CONTENTS

Introduction

Design Changes

Diagram 1: Permanent and Temporary Hardstanding Areas

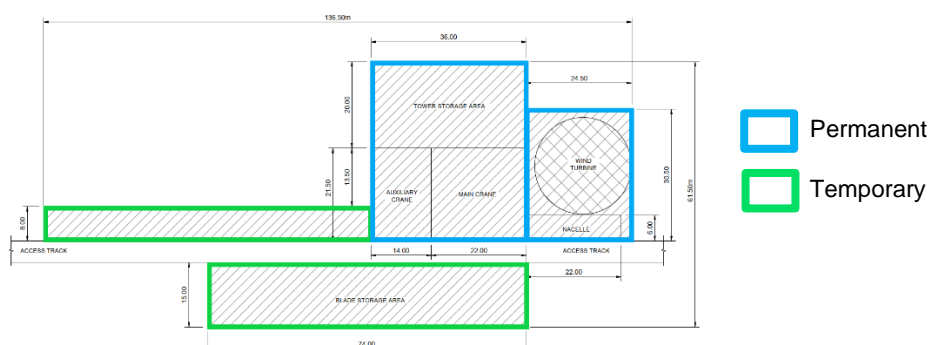
- 3.23 The number of crane hardstandings would be reduced from 10 to nine, resulting in a reduction of 0.4ha of land take.
- 3.24 In relation to **EIA Figure 3.6, Diagram 1** below confirms which areas of the proposed crane hardstandings would be permanent and temporary. These assumptions have been used in the relevant habitat loss and peat calculations in this SEI Report.
- 3.25 The temporary areas (blade laydown and storage areas) would be reinstated post construction. Where required, support areas within the blade laydown area would be arranged at suitable locations to avoid any deeper areas of peat minimising the disturbance of peat within this area.
